STATE OF HAWAII DEPARTMENT OF TRANSPORTATION HIGHWAYS DIVISION	
GABION WALL AND APRON DETAIL	
CASTLE HILLS ACCESS ROAD Drainage Improvements, Phase 2 FEDERAL-AID PROJECT NO. STP-0300(125)	
Scale: As Shown	Date: December 2011
SHEET No. C5.1 OF C5.4 SHEETS

ADD. 17

CASTLE HILLS ACCESS ROAD
Drainage Improvements, Phase 2
Federal-Aid Project No. STP-0300(125)

SHEET No. S2.3 OF 17 SHEETS

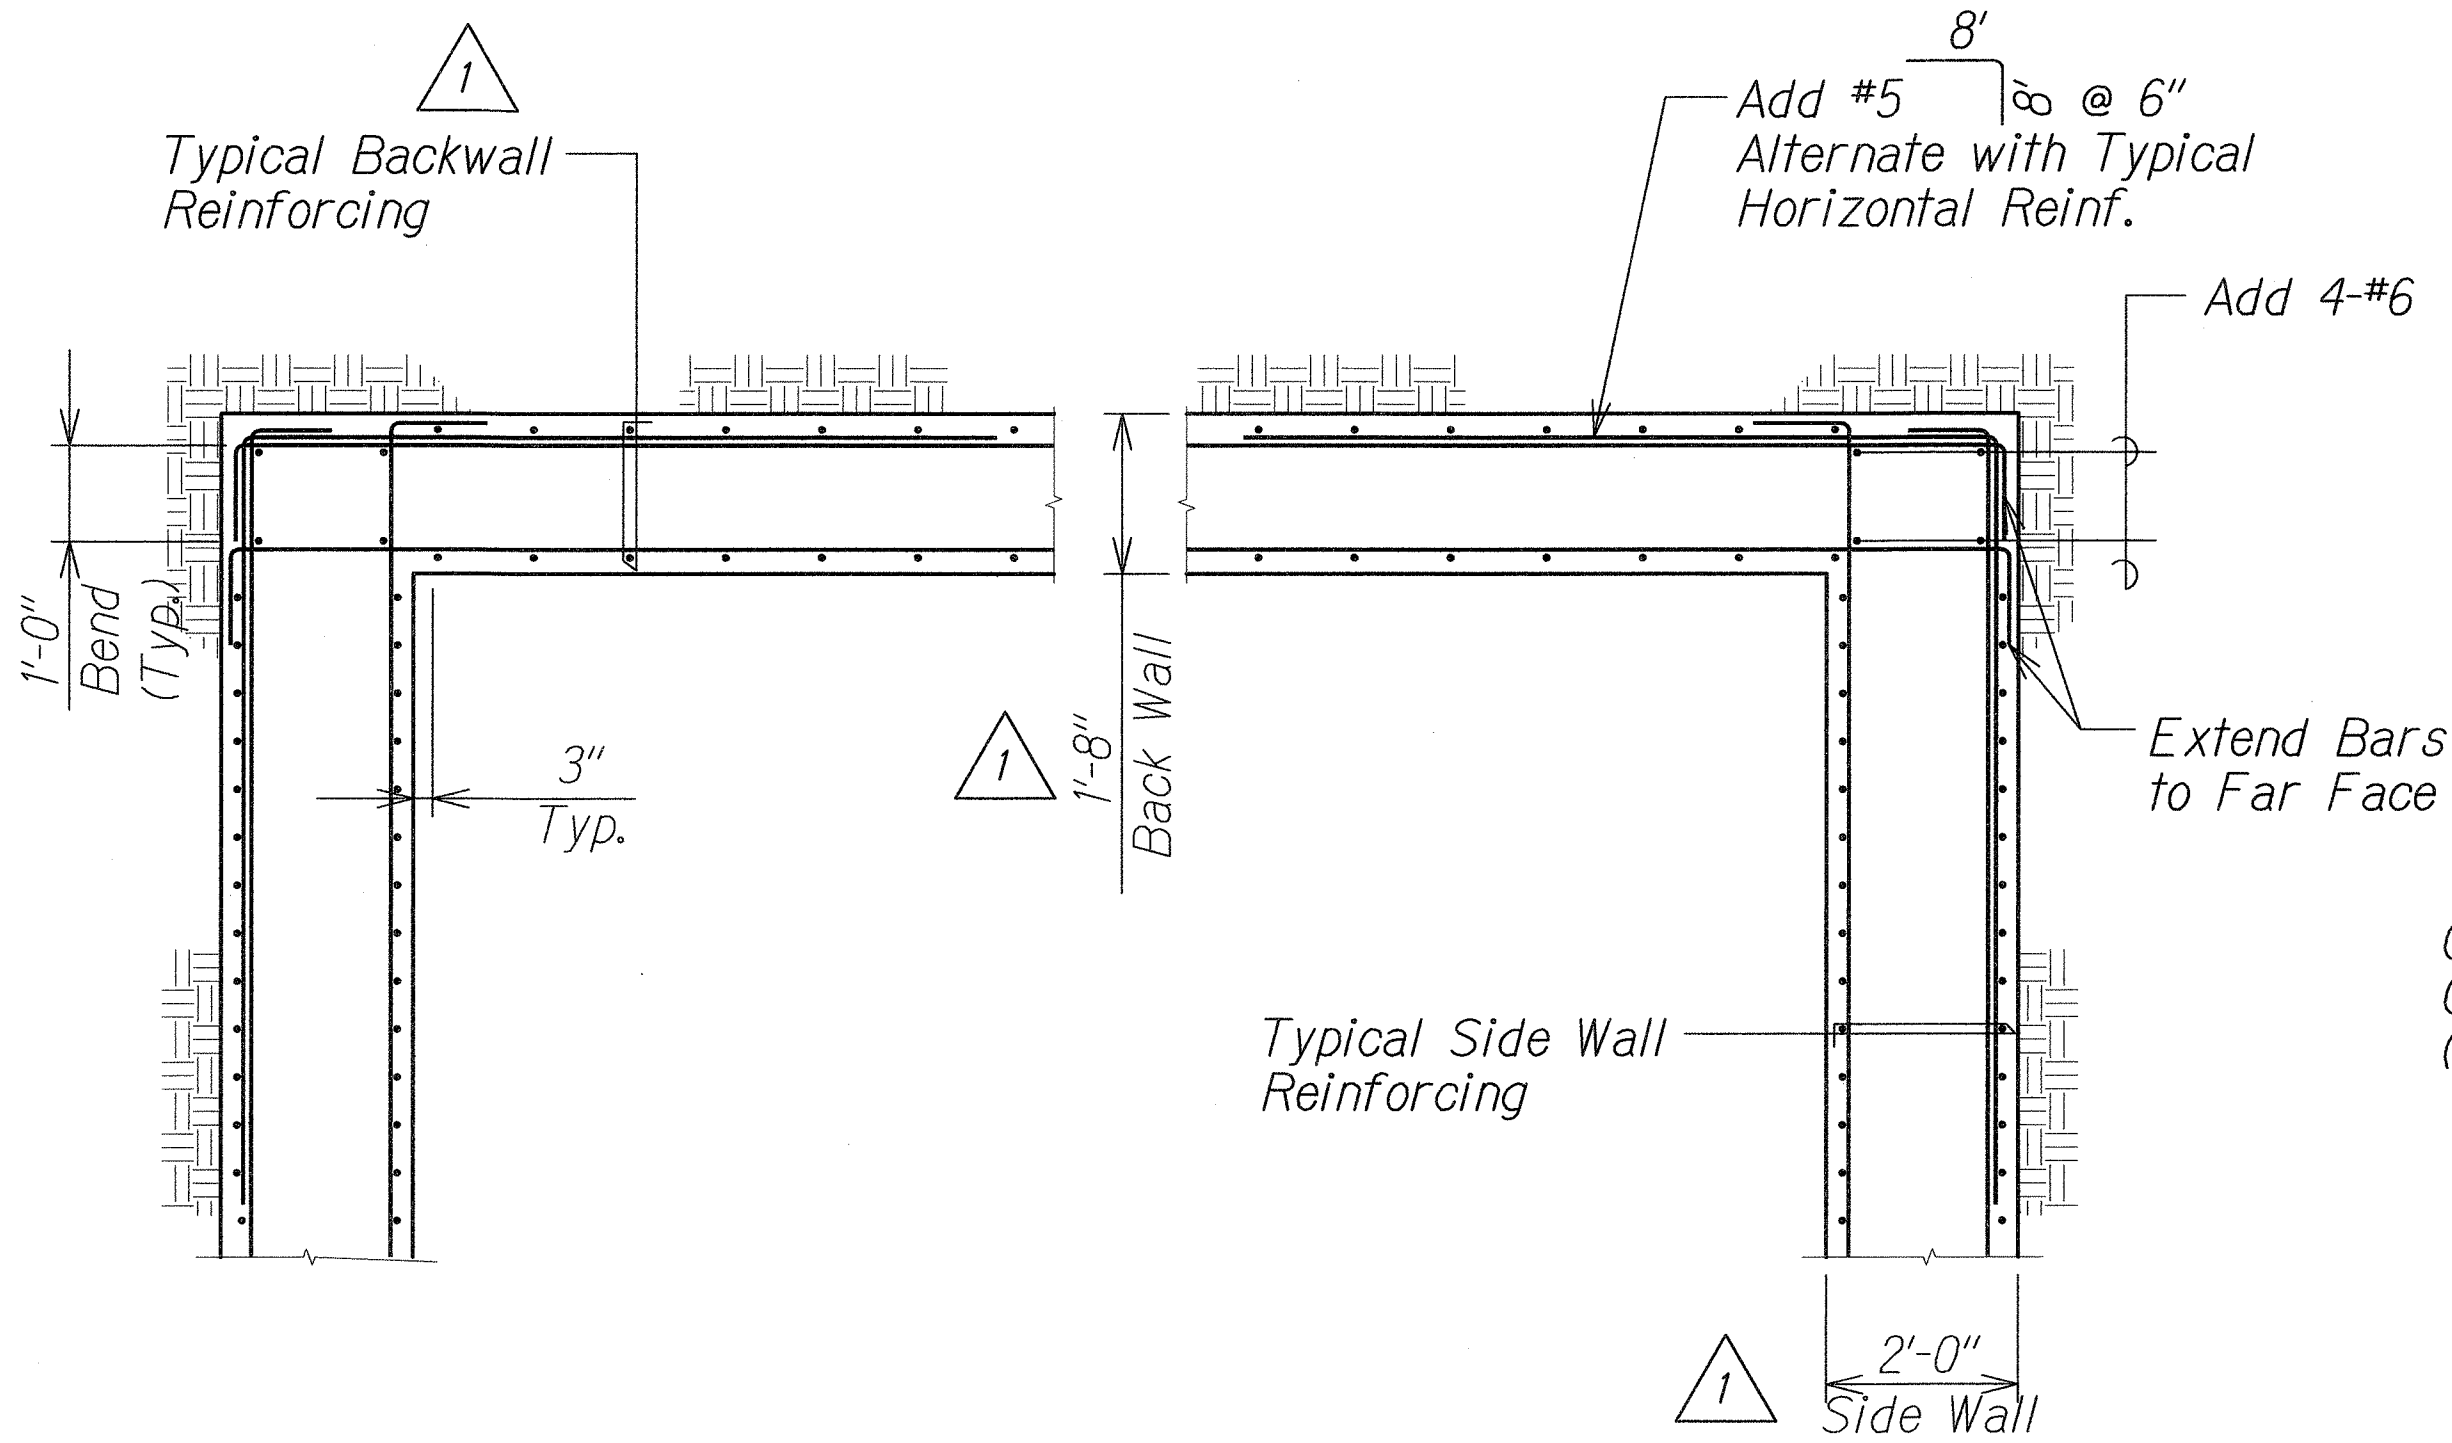
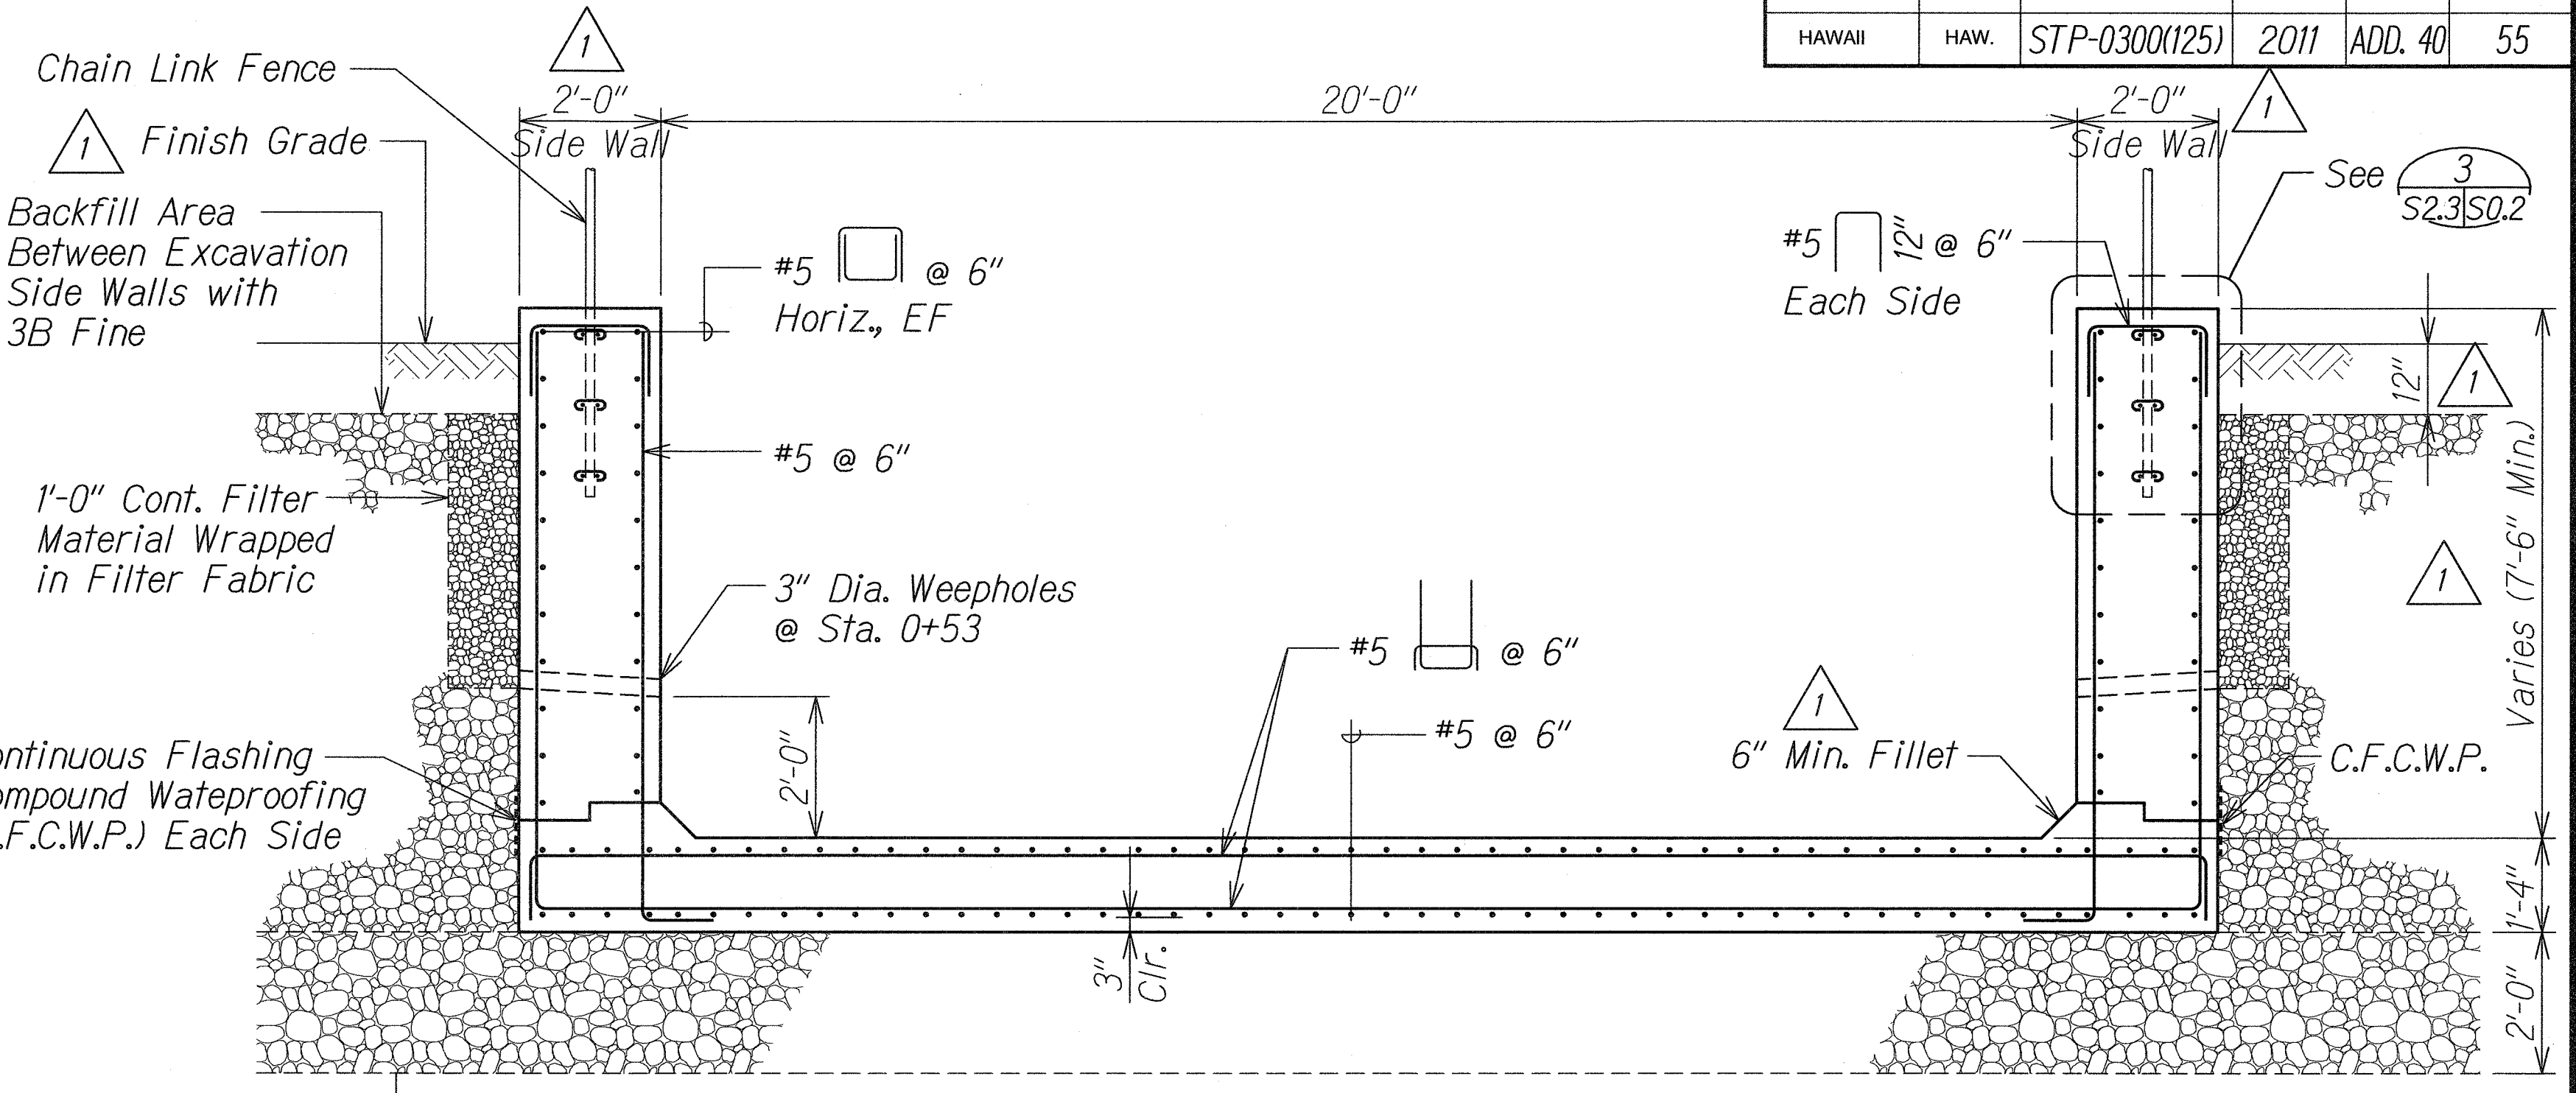
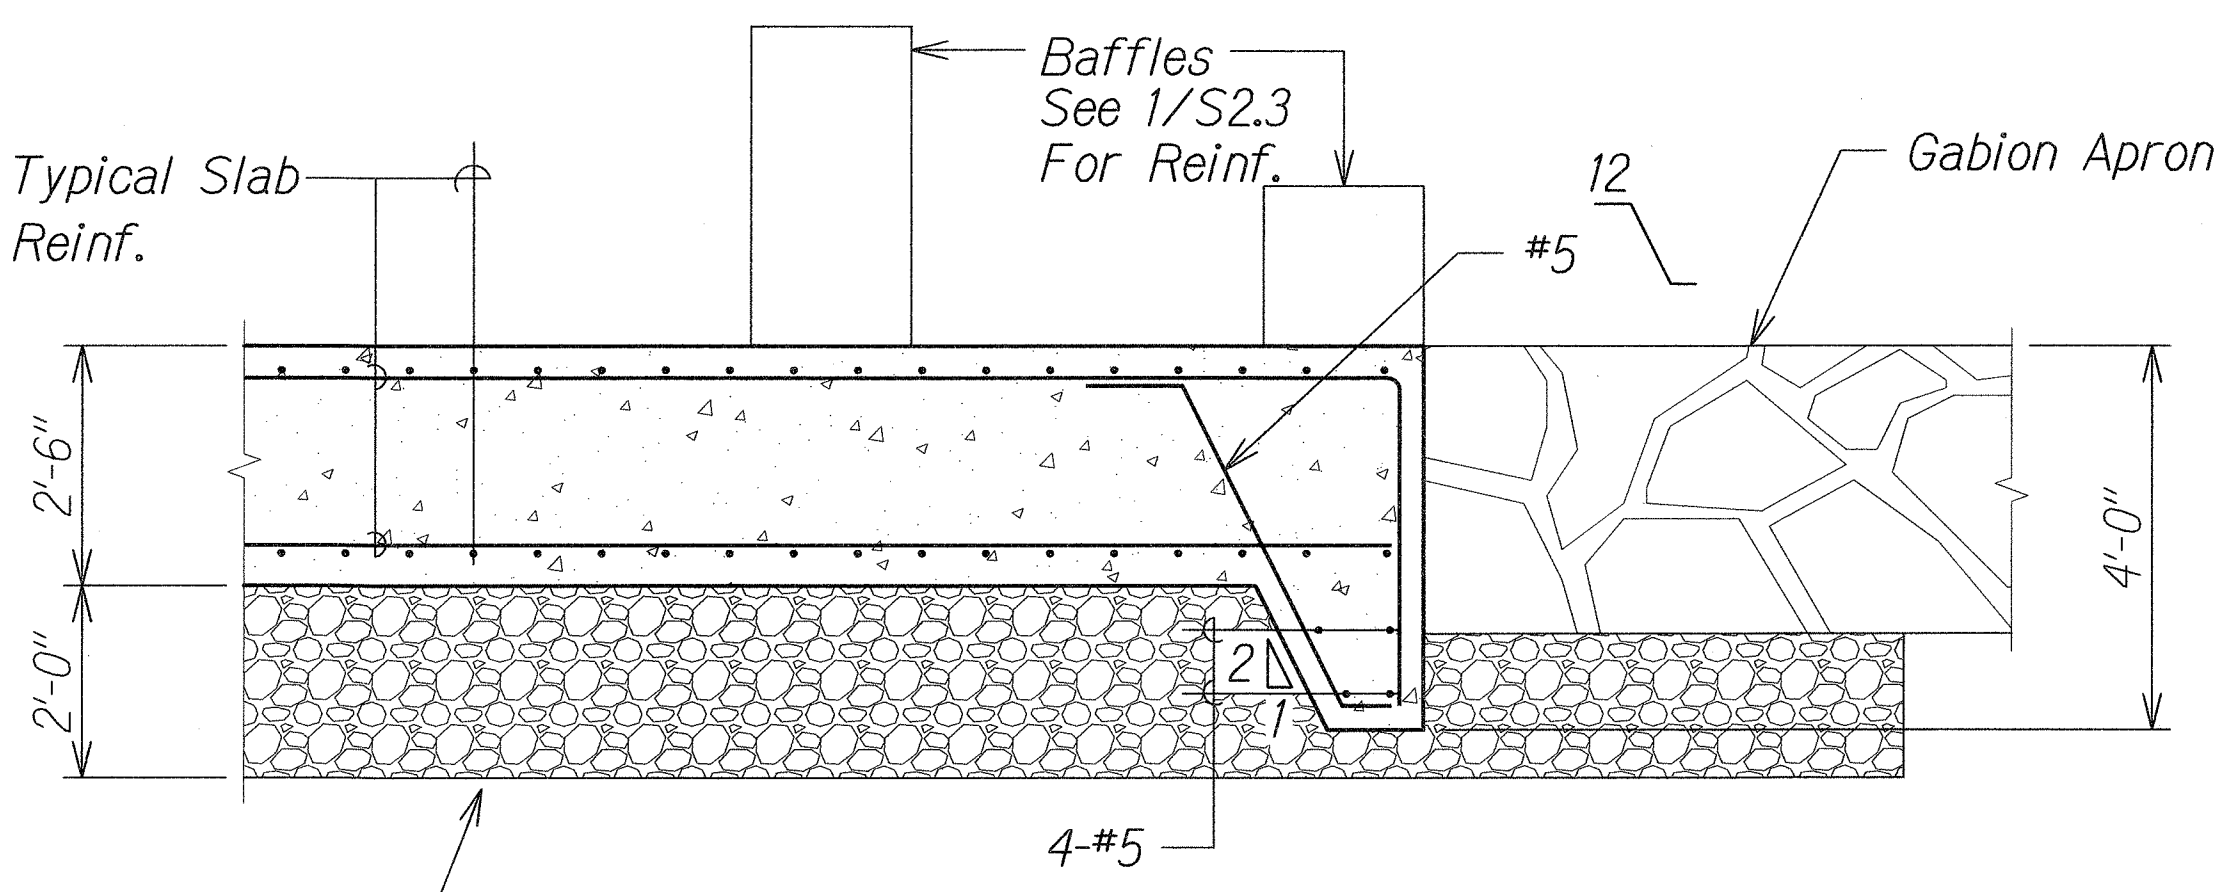
01/19/12	1 Note Clarification.
DATE	REVISION
